UN Regulation No. 67 (LPG vehicles)

Proposal for amendments to UN Regulation No. 67 (LPG vehicles)

Submitted by the expert from Italy*

"Figure 6
Connecting area of the J15 filling unit

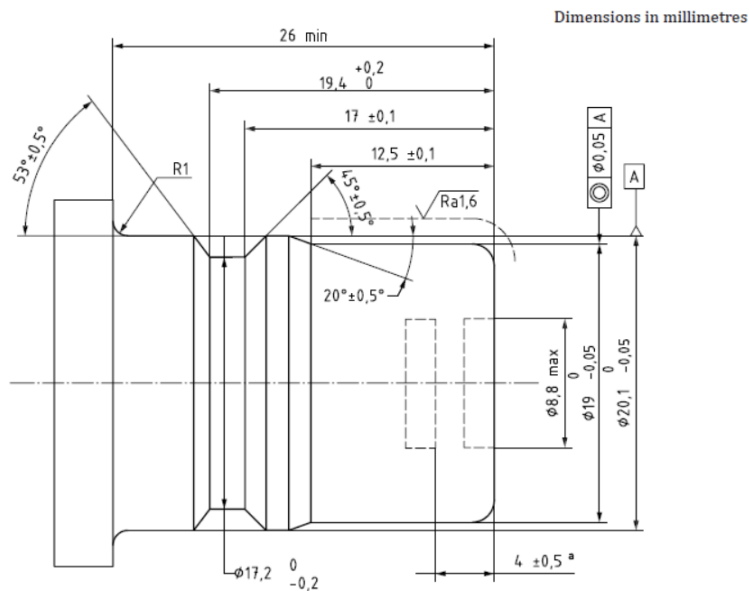
After Figure 5, insert a new Figure 6:

This proposal aims to align UN Regulation No. 67 with ISO19825. For that reason the name of light vehicle Euro filling unit is changed to K15 according to the above mentioned ISO standard, and a new profile J15 is inserted in Annex 9.
